project
**Crestwood Estate
Jim Goldston Avenue,
Norman Gardens**

**Reconfiguration Plan
Stages 7 & 8**
(1 Lot into 30 Lots + PUL + Balance)

**DEVELOPMENT PERMIT FOR RECONFIGURATION OF A
LOT (1 LOT INTO 2 LOTS WITH DRAINAGE RESERVE)**

Response to Information Request D-1647/2007

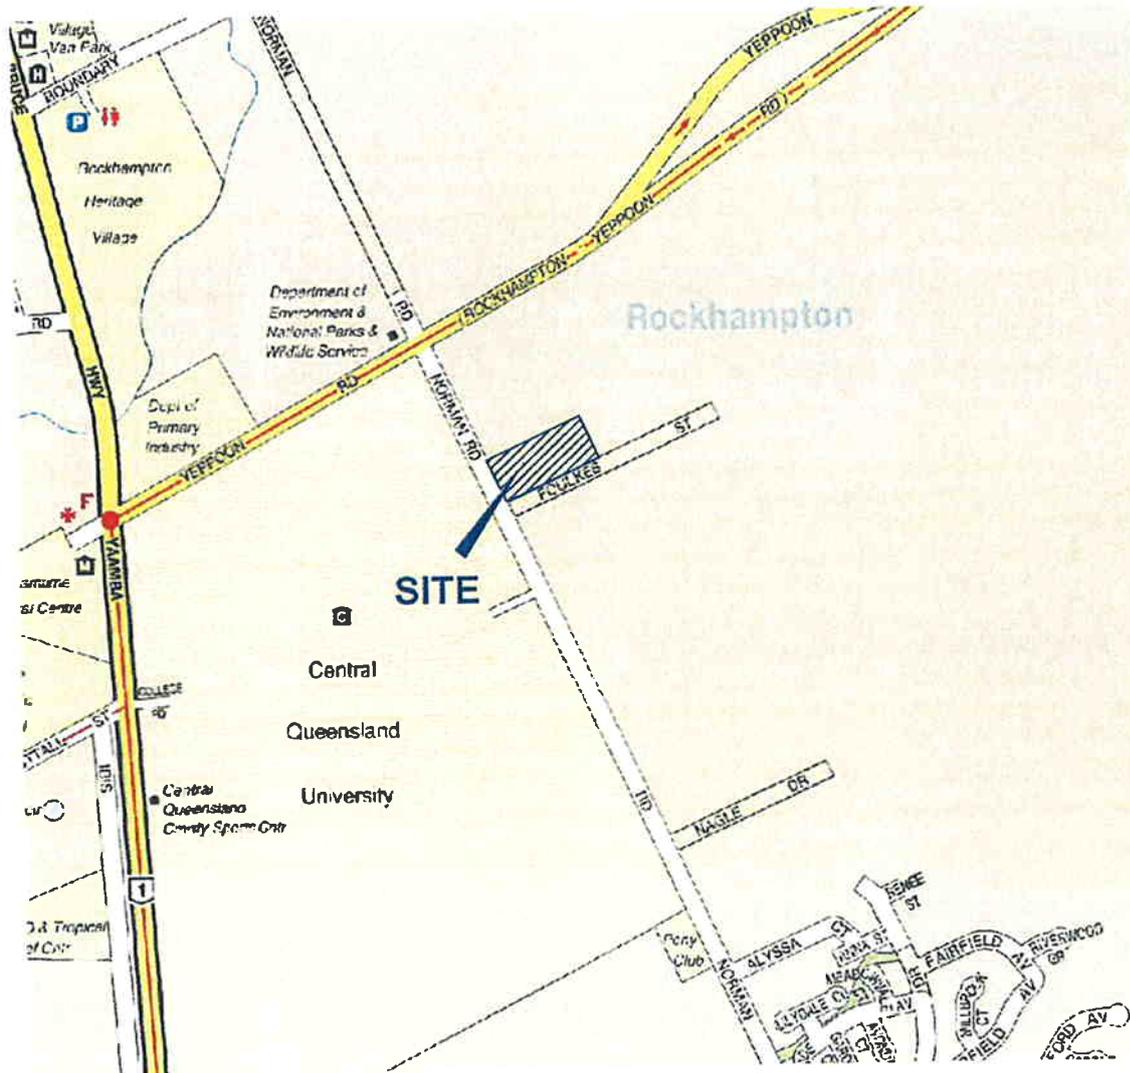
Please provide a Flood Study, prepared and certified by a suitably qualified and experienced Registered Professional Engineer of Queensland (RPEQ), for the major watercourse traversing the site (Lot 2 on RP618770). This Flood Study shall determine and clearly report all relevant engineering design details associated with flooding in the watercourse and the proposed open channel including, but not limited to, the following:

Based on the calculated flood levels for the developed scenario, it can be noted that the maximum increase in flood level within the site for this scenario is 830 mm. This afflux has a negligible impact on the site as it will be contained within the proposed channel at all times.

Present results also showed that Foulkes Street is immune to flooding in occurrence of the 100 year ARI event. However, Foulkes Street and its associated culvert cause a maximum increase in flood levels of 1260 mm upstream of the site in occurrence of the 100 year ARI storm event. This afflux will be dissipated within 350 metres from the upstream side of the culvert.

Obtained velocities indicate that a maximum velocity of 1.80 m/s will occur within the proposed channel. The longitudinal slope of the channel varies between 1.1 and 2.0 %, the banks of the channel are considered to comprise erosion resistant soil, as the invert of the channel will be grassed and the batters of the channel will be lined with a jute mat and landscaped plantings. Therefore the obtained velocities are lower than the permissible velocities recommended in Table 9.05.3 of QUDM 2007 for channels with gradients between 1 and 2 % (2.1 to 2.8 m/s).

FIGURE 5 PROPOSED CHANNEL CROSS SECTION

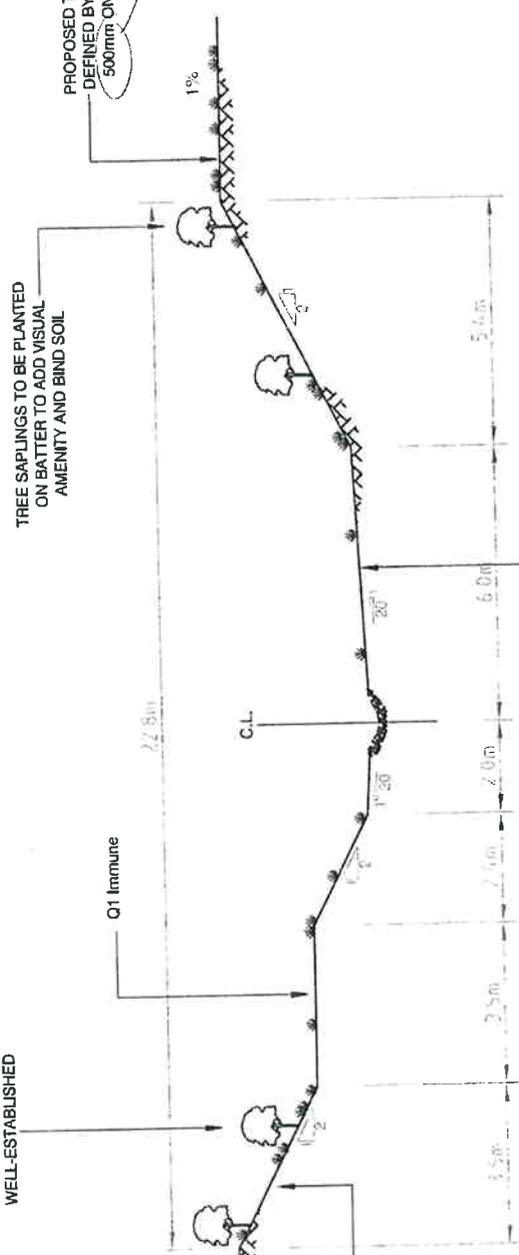
(f) Please demonstrate how the proposed open channel will provide for low-flow events consistent with the Capricorn Municipal Development Guidelines and the Queensland Urban Drainage Manual.

- (a) the proposed drainage channel has 1:2 batter slopes and is retained by the use of MaxJute or similar product anchored into the banks (in accordance with the manufacturer's specifications), in conjunction with landscaping that considers native plants, low maintenance, durability and good visual amenity (as detailed in Item 4). The roughness of this channel profile has adequately been incorporated into the HEC-RAS model, which is shown within the Flood Study attached in Appendix E.

- (b) this is addressed in the Flood Study attached in Appendix E.
- (c) it is proposed that a 3.5m wide maintenance berm above the Q1 level, is to provided in the base of the drainage channel in order to allow service vehicles access to the base. This is shown in the typical detail on Dwg. 439101-153-002 Rev C attached in Appendix A. This has also been incorporated into the HEC-RAS model used for the Flood Study.

The new 23 metre wide channel will generally have 1:2 batter slopes and will be approximately 3.26 metres deep. A 3.5 metre maintenance berm will be located within the channel above the inundation level corresponding to the 1 year ARI event. A cross section of the proposed channel is shown in Figure 5. The invert slope of the proposed channel along the subject property will be 2 % (1 in 50) while the invert slope of channel within Lot 1 on RP618770 will be 1.1% (1 in 90). The proposed channel includes a 1.5 metre wide, 0.3 metre deep low flow trapezoidal drain. The invert width of the proposed channel will be 8 metres and will have a crossfall of 1 in 20.
